Duke Power Company
McGuire Nuclear Station
Catawba Nuclear Station

Rod Swap Methodology Report
For Startup Physics Testing

DPC-NE-1003-A
Revision 1

SER Dated October 1, 2002

Rod Swap
Rod Exchange with Two Test Banks

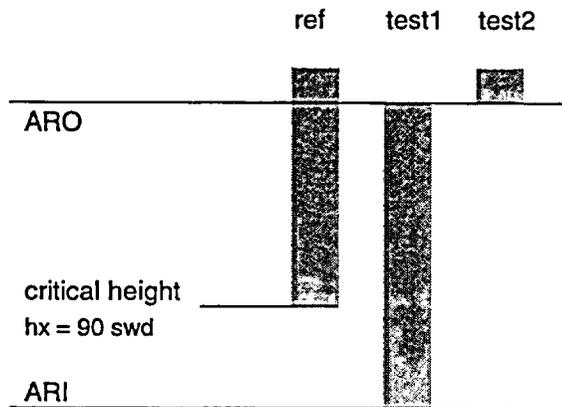
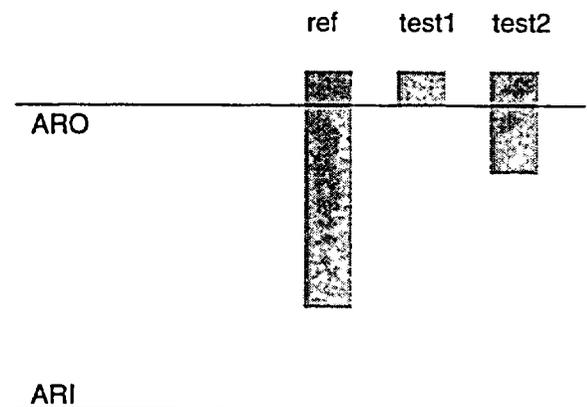
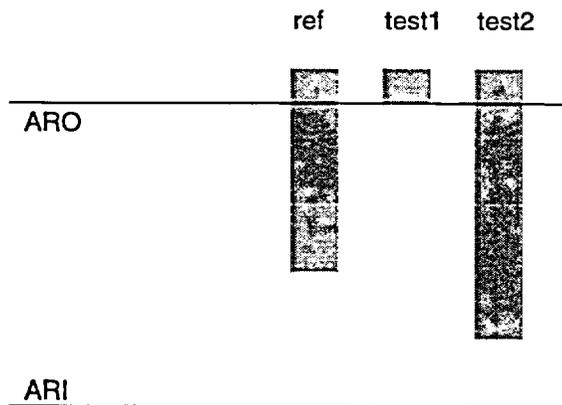
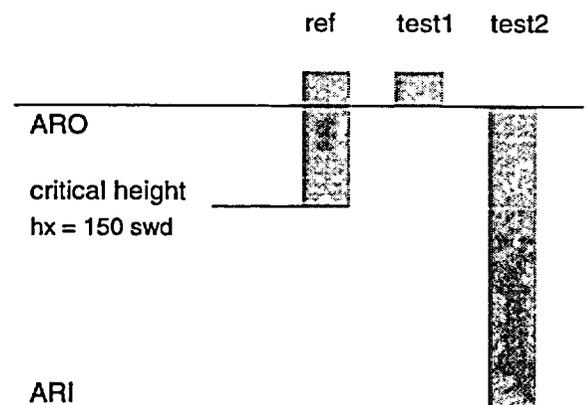
Question 4. The third sentence in Section 3 of the topical report is revised to read: "All other banks are then exchanged with the reference bank or other test banks at constant boron conditions until the measured bank is fully inserted." It is stated, in Attachment 9a - Detailed Listing of Changes to DPC-NE-1003A, that the third sentence in Section 3 is revised to make the report consistent with current procedures. The "Revision History" in the topical report states that this revision [Revision 1] also reflects a refinement in the rod swap to make use of two test banks.

- a. What is the "current procedures"? What is the date of the current procedures?
- b. Are the current procedures the same or different from the one in Attachment 3? The Attachment 3 procedures did not include the exchange of a test bank with other test bank.
- c. If the "current procedures" are different from that of Attachment 3 or 4, provide a copy of the procedures, and appropriately reference it in the report.
- d. Is the statement in "Revision History" referring to this revision? Please explain what the statement means.

An information only copy of the current McGuire procedure is included in Attachment 4 of this response package. The topical report only makes a general reference to the plant procedure.
